SERVICE BULLETIN

Service Bulletin No.	SB-ESCAPE214_002
Service Bulletin Affected Parts	Tail rotor drive shaft
Revision	Rev. 00
Issue date	13 July, 2026
Classification	Mandatory
Aircraft type / model	ESCAPE 214
Affected serial numbers	007 - 008
Prepared by	Alessandro Berion
Approved by	Roberto Lamanna

Summary

Fig. 1.0: Tail rotor drive shaft representation in the overall helicopter assembly.

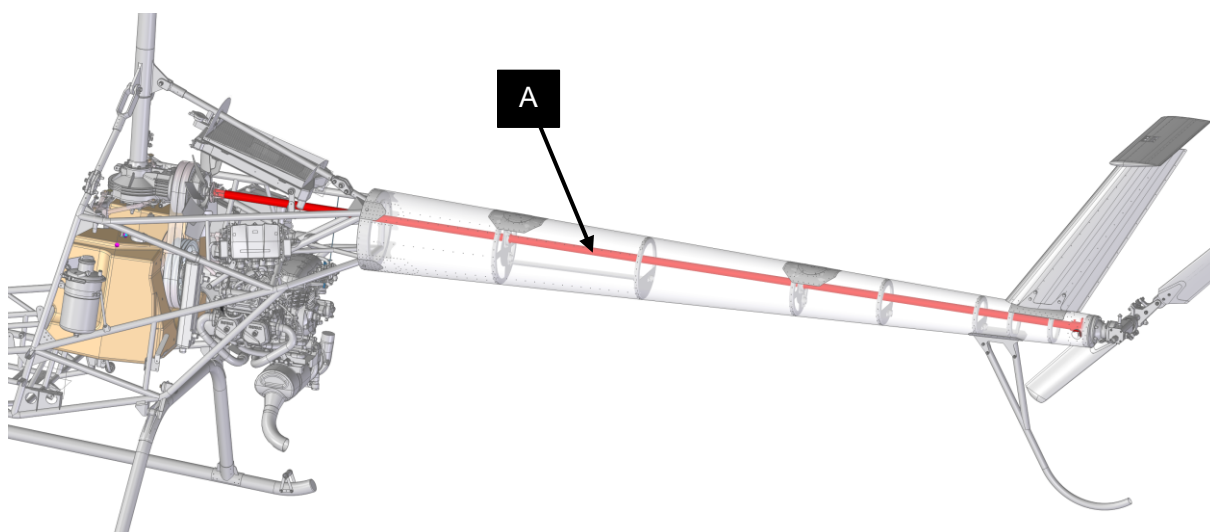
Following the detection of a straightness non-conformity on the tail rotor drive shaft, causing cyclic vibration, LAMANNA HELICOPTER prescribes the replacement of the drive shaft and the subsequent tail rotor balancing, as described in this Service Bulletin.

It has been found that the tail rotor drive shaft presents a straightness non-conformity, which generates a cyclic vibration during operation. This vibration prevented tail rotor balancing, as the data read by the accelerometer was distorted. The issue is resolved by replacing the shaft with a component conforming to the standard defined by LAMANNA HELICOPTER.

Replacement of the tail rotor drive shaft and perform tail rotor balancing.

Fig.	Position	Part no.	Qty	Description	Application
1.0	A	LH212-008-001-000	1	Tail rotor drive shaft assembly	Overall helicopter assembly
